Access Compliance Report

Public Rights-of-Way

Intersection ID: 45134	Main Street: DULIN_CREEK_BV	Cross Street: LITTLE_WHITEOAK_RD	Location: SW
ADA ID: DF121ECCC929	Ramp Type: PerpDiag	Initial Pass/Fail: Fail	Overall Compliance: No
Severity Score: 10			
Codes/Mitigation Info/Possible Solution		Field Measurements/Component Compliance

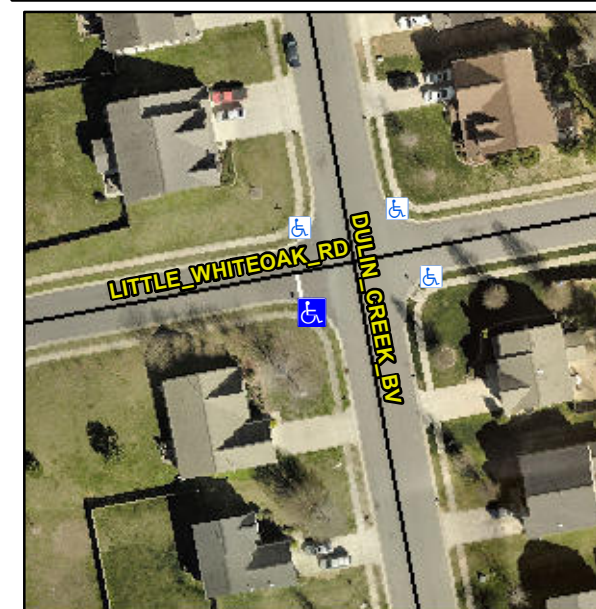
Not Found, R304.5.1, R304.5.3

Compliance	Description	Data	Compliance	Description	Data
N/A	Ramp Length (in)	47.5	Yes	Ramp Slope (%)	5.2
No	Ramp Width (in)	42.5	No	Ramp XSlope (%)	3.3
N/A	Flare Type LT	N/A	N/A	Flare Type RT	N/A
N/A	Flare Slope LT (%)	N/A	N/A	Flare Slope RT (%)	N/A
N/A	Flare Traversable LT?	N/A	N/A	Flare Traversable RT?	N/A
N/A	Landing Length (in)	N/A	N/A	DWS Provided?	N/A
N/A	Landing Width (in)	N/A	N/A	DWS Contrast?	N/A
N/A	Landing Slope (%)	N/A	N/A	DWS Length (in)	N/A
N/A	Landing X Slope (%)	N/A	N/A	DWS Full Width?	N/A
N/A	Landing Curb? (Y/N)	N/A	N/A	DWS Offset (in)	N/A
N/A	Shared Landing?	N/A			
N/A	Gutter Ponding?	N/A	N/A	Gutter Slope (%)	N/A
N/A	Gutter Lip Ht (in)	N/A	N/A	Gutter X Slope (%)	N/A
N/A	Painted X Walk1?	No	N/A	Painted X Walk2?	No
	X Walk 1 Direction	To E		X Walk 2 Direction	To N
N/A	X Walk 1 Width (in)	N/A	N/A	X Walk 2 Width (in)	N/A
	X Walk 1 Slope (%)	5.2		X Walk 2 Slope (%)	2.5
	X Walk 1 X Slope (%)	0.5		X Walk 2 X Slope (%)	3.5

Remove & Replace Curb Ramp With Two New Directional Ramps or Equivalent.
